Vogle Project

August 1, 1988

PLANT VOGTLE - UNITS 1 & 2
NRC DOCKETS 50-424, 50-425
OPERATING LICENSE NPF-68, CONSTRUCTION PERMIT CPPR-109
FSAR CHANGES FOR RADWASTE FACILITIES

Attached are the proposed changes to the FSAR for the Dry Active Waste (DAW) Facilities, Alternate Radwaste Building (ARB), Control Area modification, and the ARB bridge crane addition. Existing warehouses located on the southwest portion of the owner controlled area are being extensively modified to handle the DAW. A new addition to the ARB will house the ARB Control Room and dress-out area. The existing pedestal crane in the ARB is being replaced by a bridge crane.

FIGURE 9.4.3-5 (SHEET 6 OF 8)

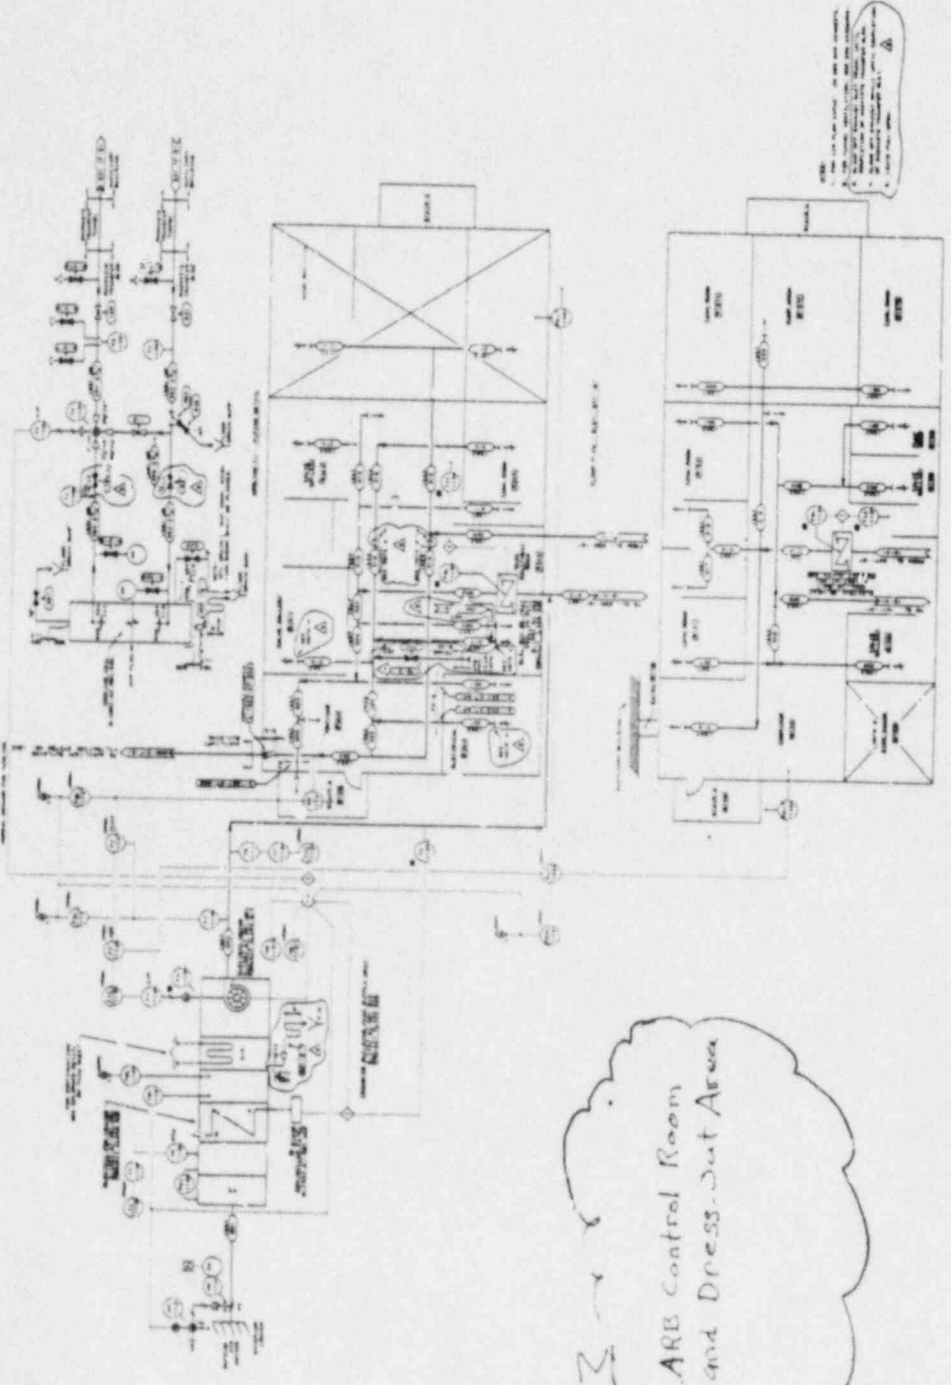
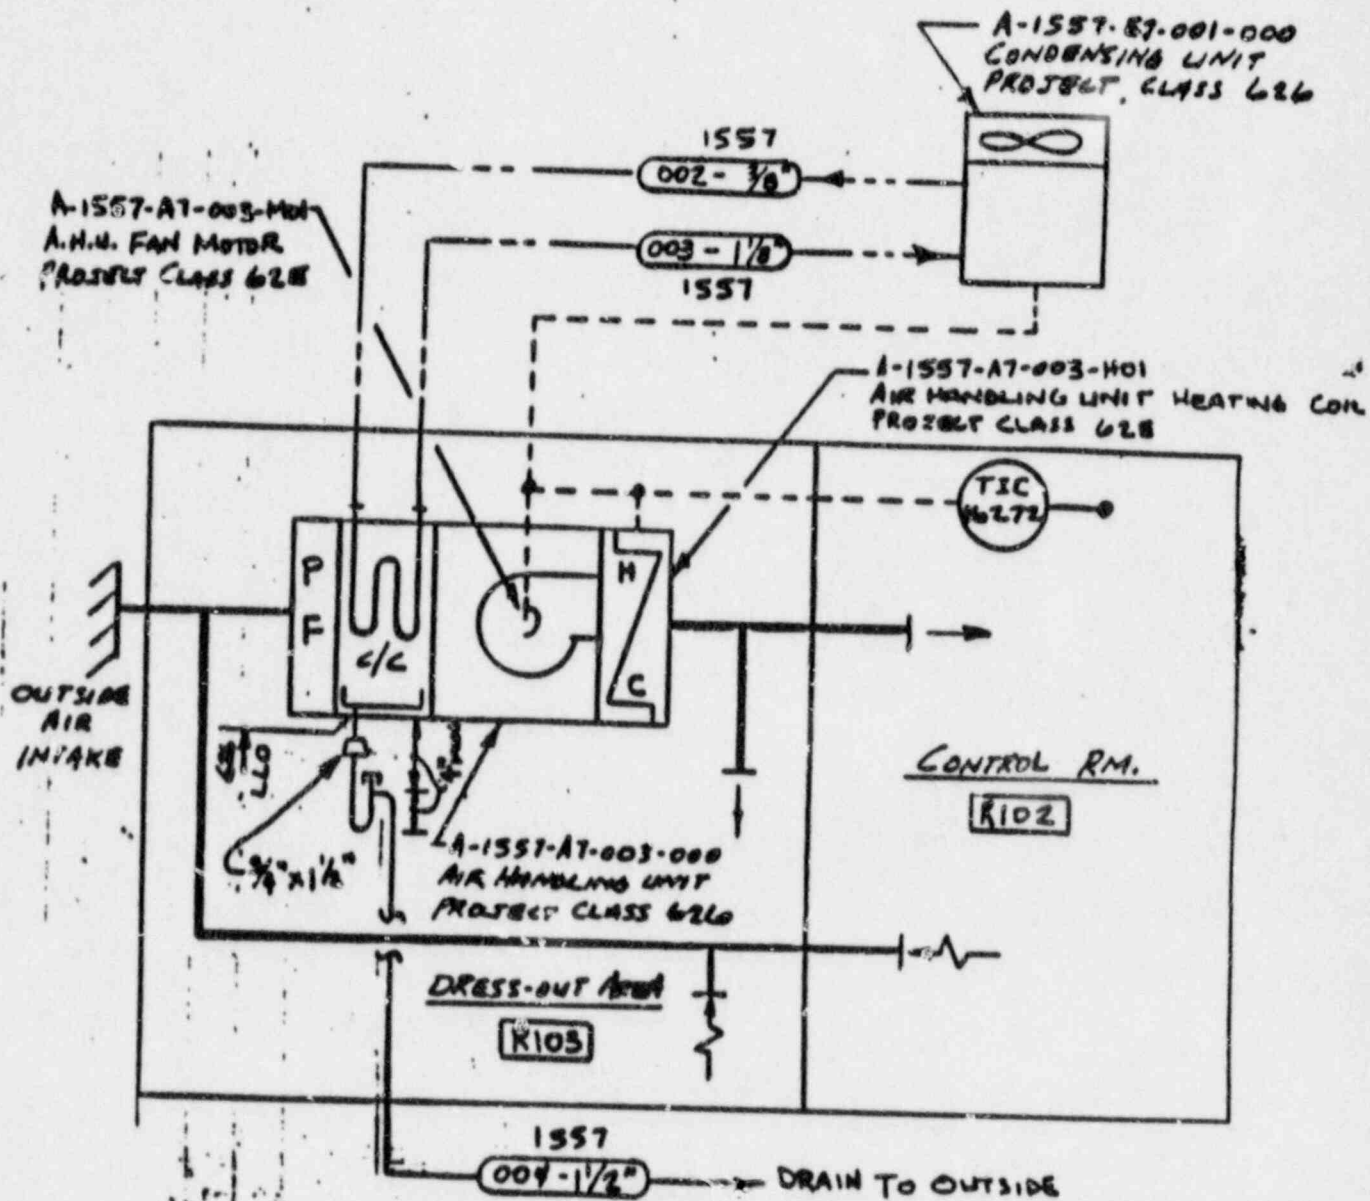
ADD

Add (attached) ARE Control Room and Dress-out Area

ADD TO FSAR
 FIGURE 9.4.3-5 SH.6

AX-40878 REV. 3
RADWASTE BUILDING FLOW DIAGRAMS
FIGURE 9-4.3-6 (SHEET 5 OF 7)

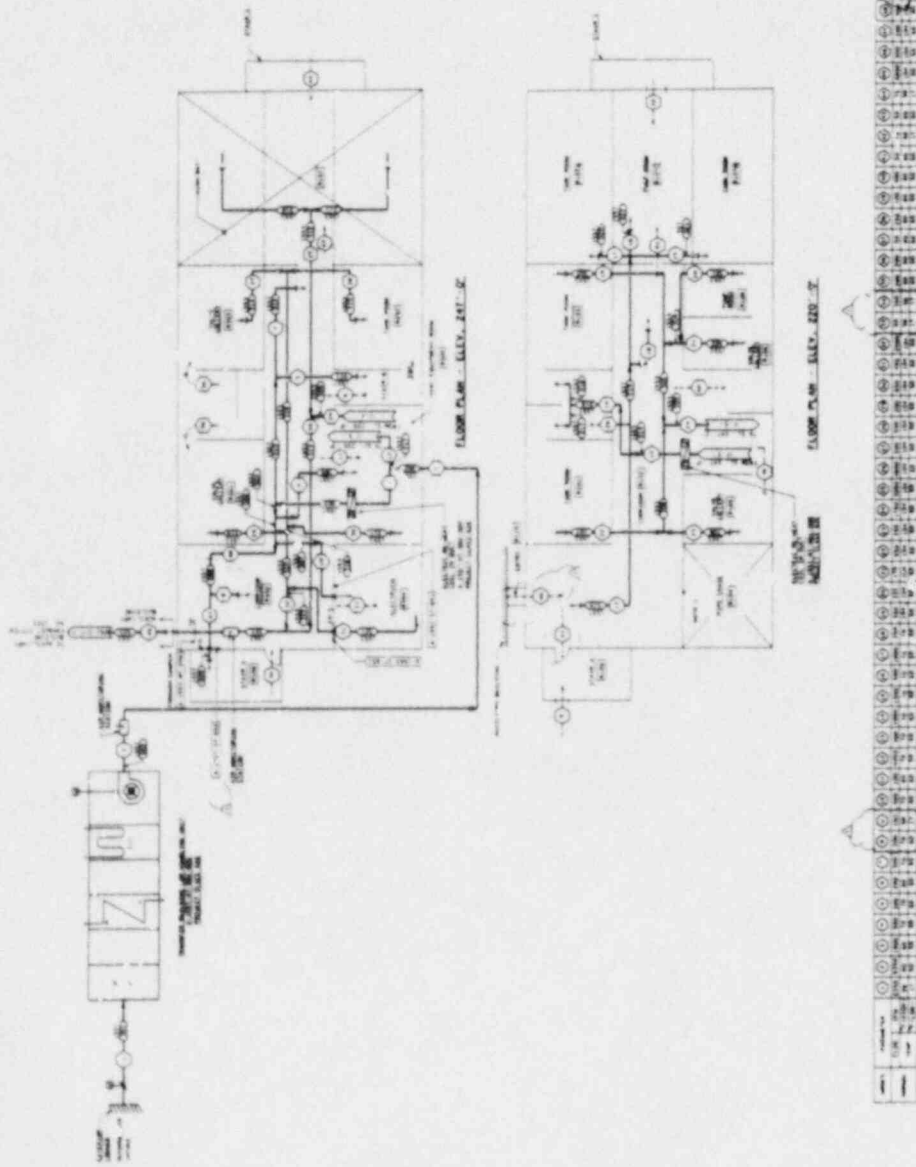
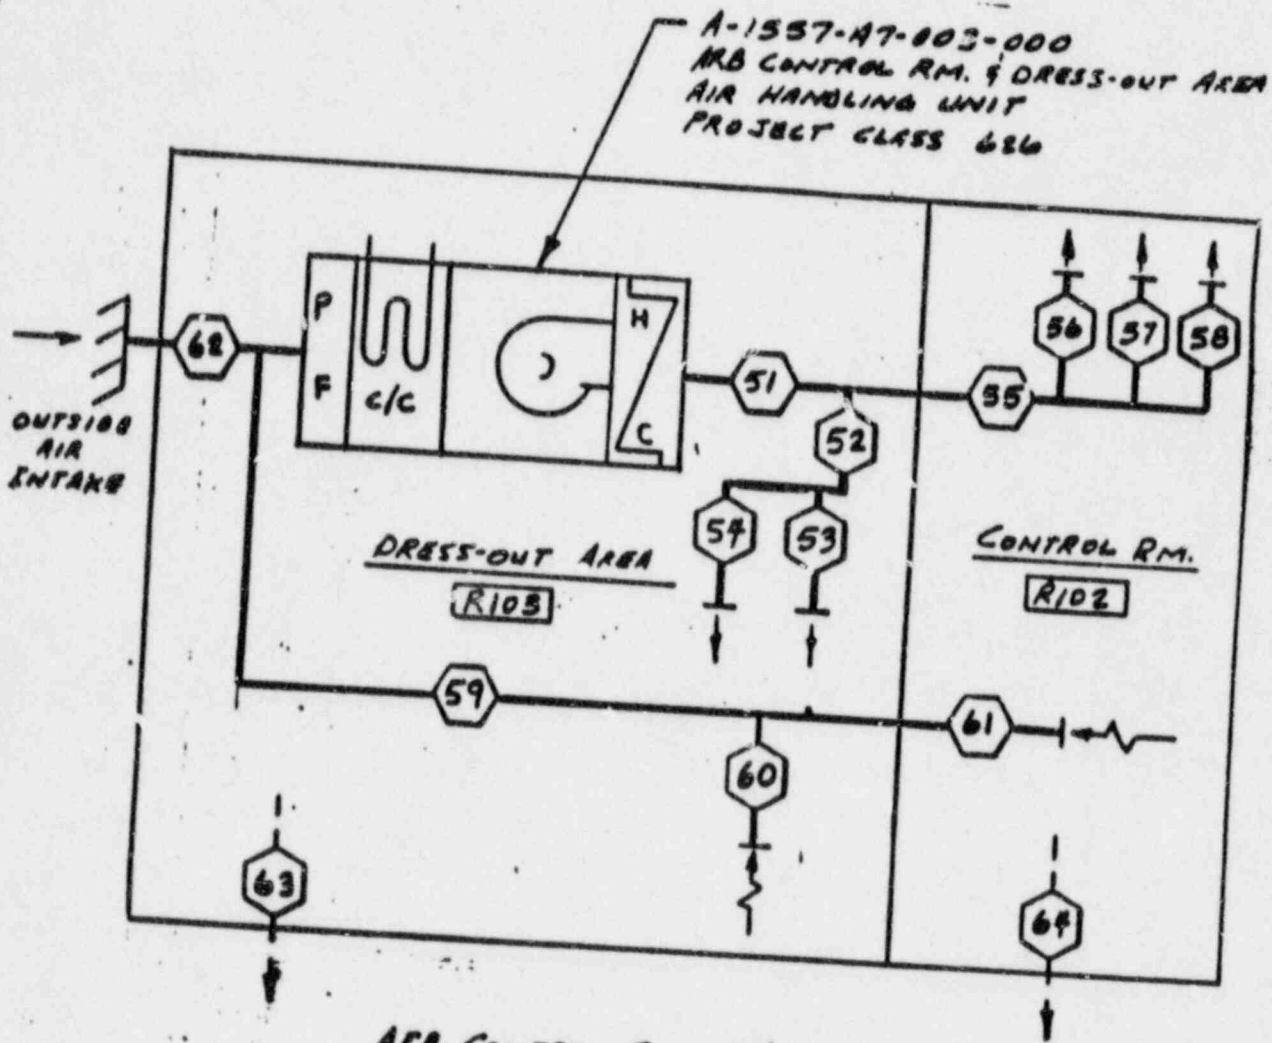
ADD TO FSAR
FIGURE 9.4.3-6 SH.5

4. ARB CONTROL ROOM AND DRESS-OUT AREA TO BE MAINTAINED AT SLIGHTLY POSITIVE PRESSURE WITH RESPECT TO ADJACENT AREAS.

ADD TO FSAR
FIGURE 9.4.3-6 SH. 5

LIGHTING SYSTEMS SCHEMATIC
 FIGURE 9.5.3-1 (SHEET 3 OF 3)

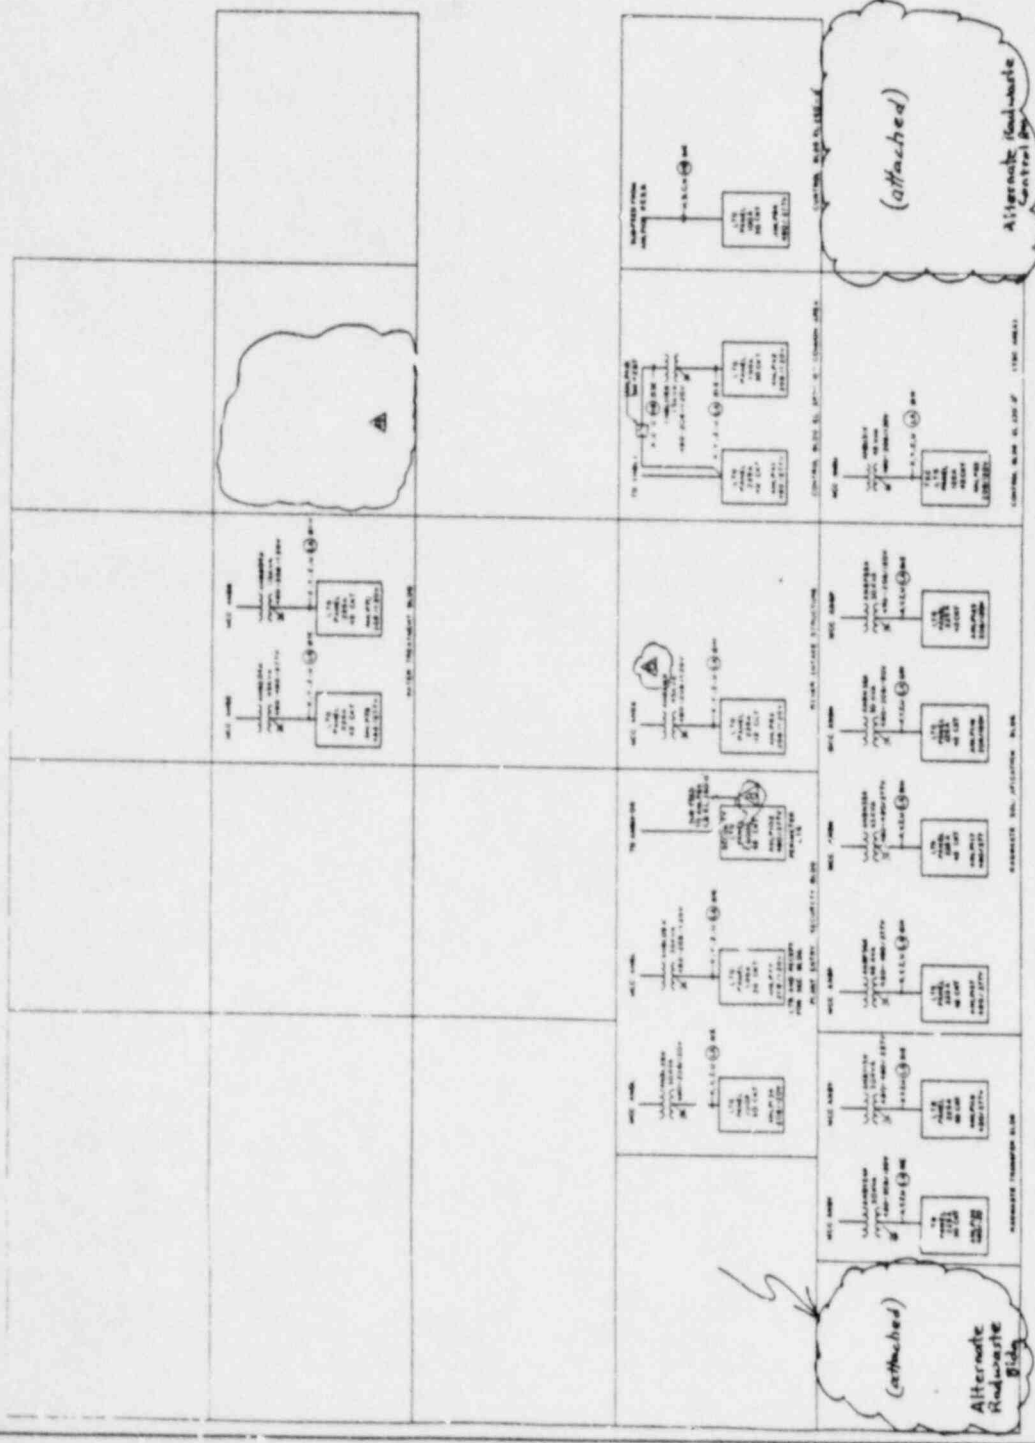
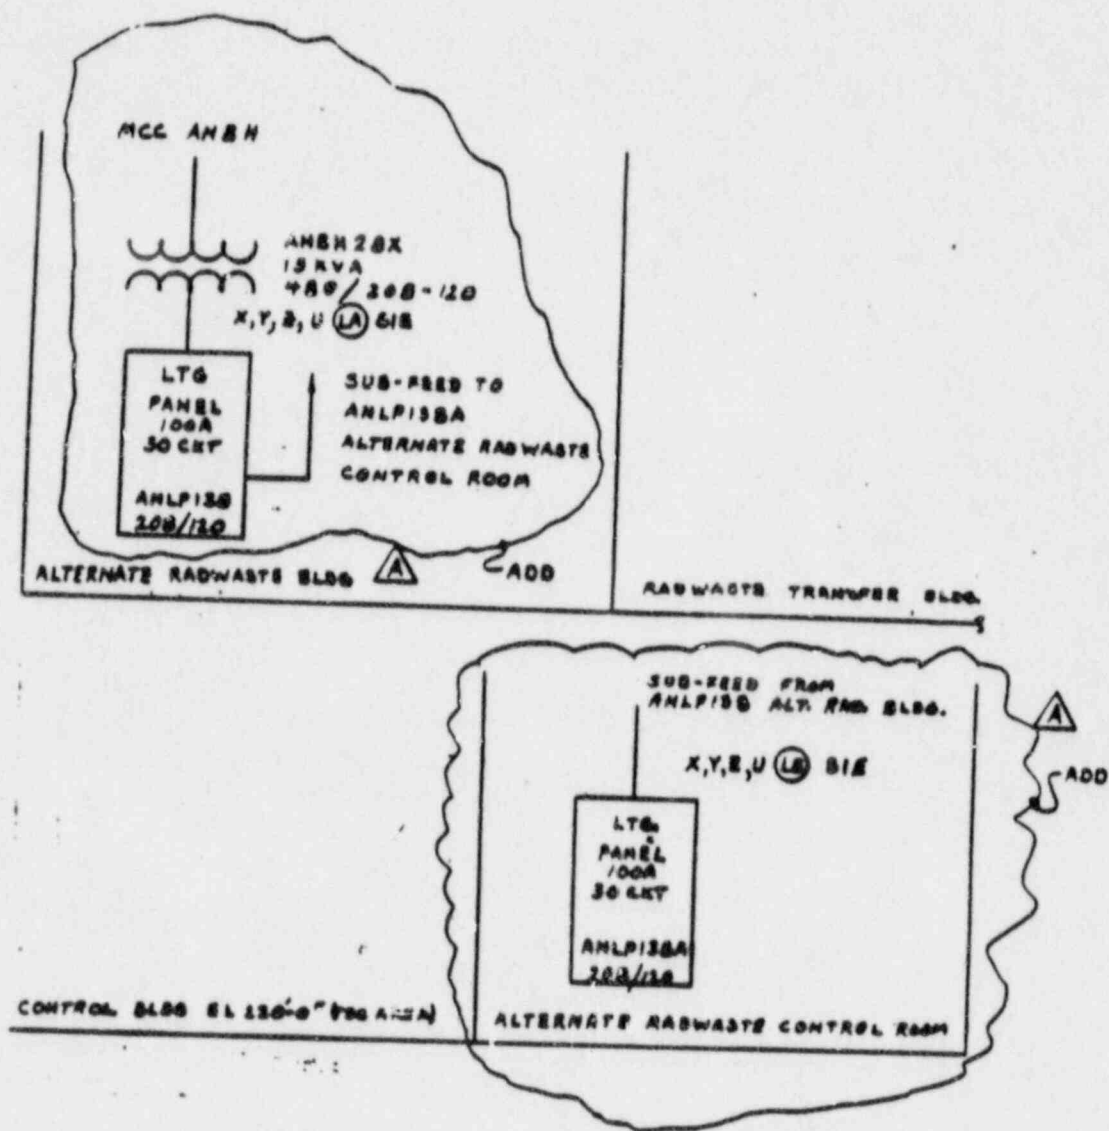
"PROPOSED CHANGES"

LIGHTING SYSTEMS SCHEMATIC
FIGURE 9.5.3-1 (SH. 3.43)

FIGURE 9A-42

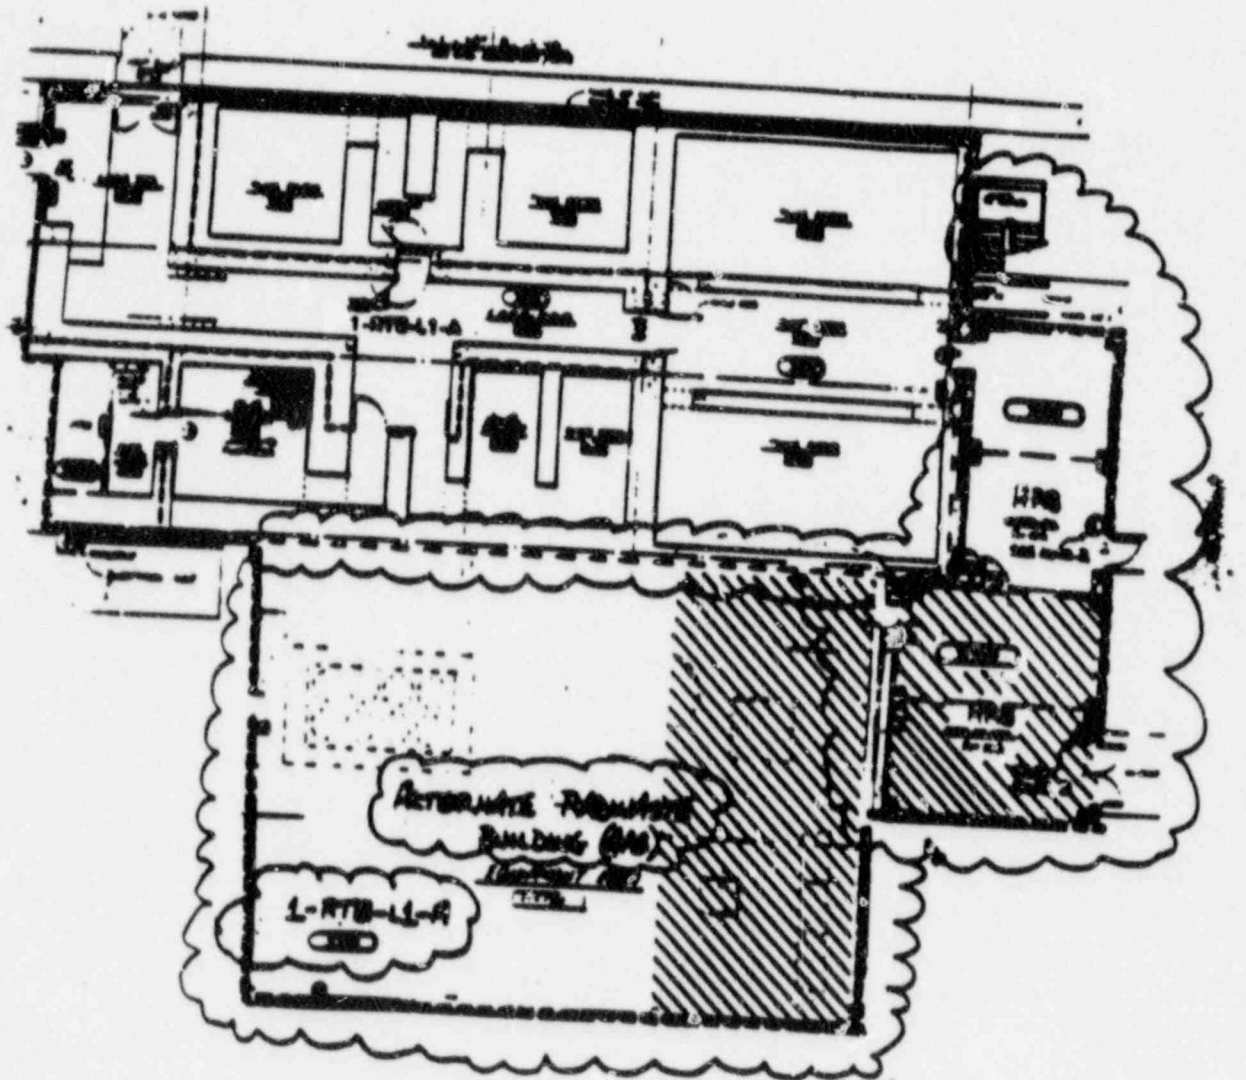
PROPOSED CHANGES

FIRE AREAS RADWASTE TRANSFER
BUILDING PARTIAL LEVEL 1
FLOOR PLAN EL. 237'-0"
FIGURE 9A-43

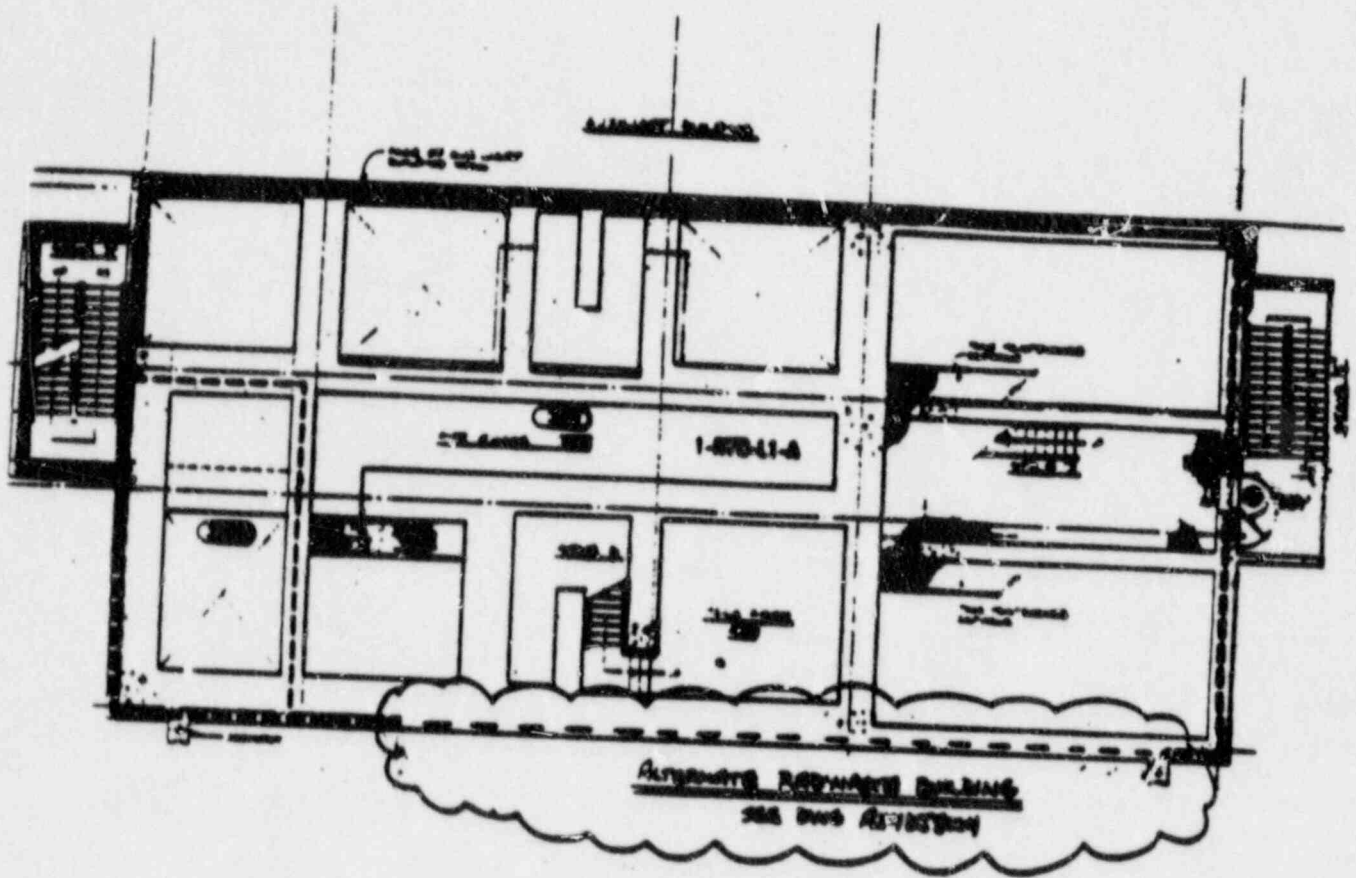
PROPOSED CHANGES
